Re: Amendment to the Remedial Action Plan
Appleton Wire (Former)
908 N. Lawe Street
Appleton, Wisconsin 54911
BRRTS# 02-45-000015

This letter presents an amendment to the Remedial Action Plan (RAP) submitted to the department on April 11, 2019. As described in the RAP, the plan for remediation outside the warehouse to the north included soil blending to 15 feet below ground surface (bgs) starting at a distance of 5 feet from the north wall. A line of injection points just outside and parallel to the wall was proposed to treat contaminated soil and groundwater around the footing(s).

Figure	16
Project	6486

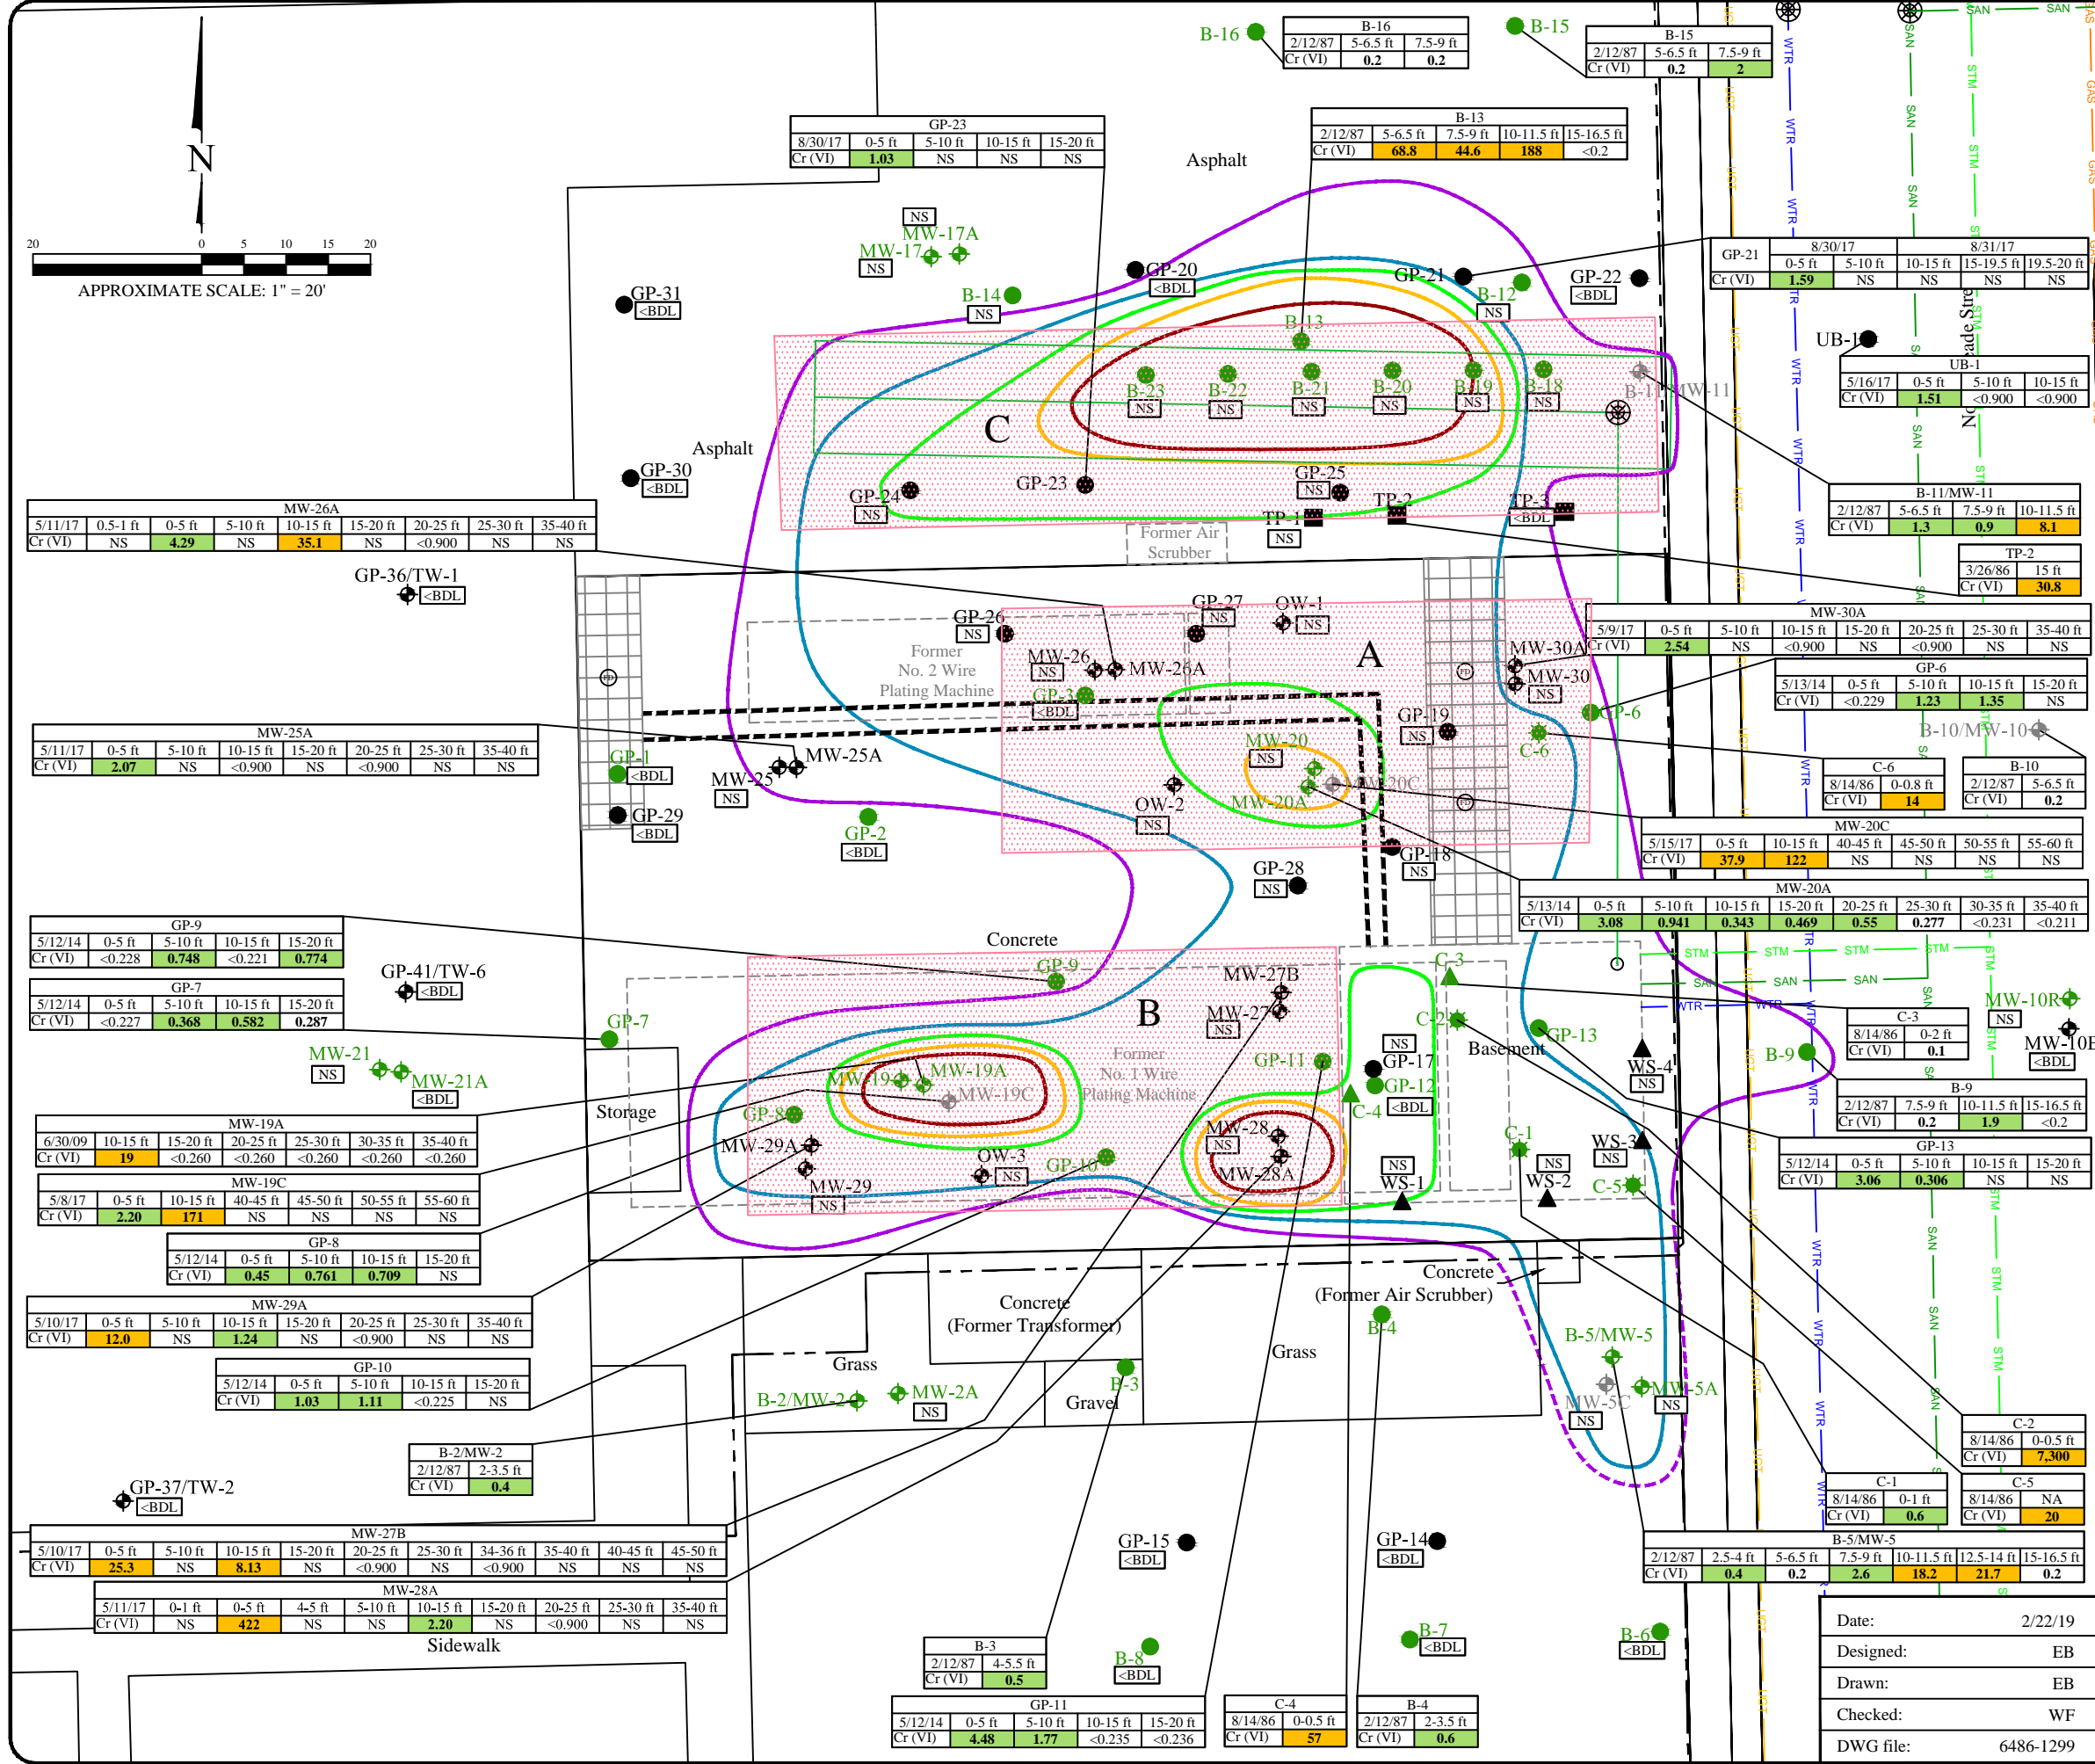
1. Additional injection points have been added further north of the warehouse wall, and this area has been designated injection Area F as depicted on revised **Figure 15** (attached). The remedial solution will be injected from 6 to 20 feet bgs in the Area F injection points at the same mixing ratio and volume prescribed for the other injection points.
2. Soil blending operations in Area C (see RAP **Figure 16**, attached for reference) will start 6 feet north of the building wall, and the blending depth will be restricted to 6 feet bgs across the entire area.
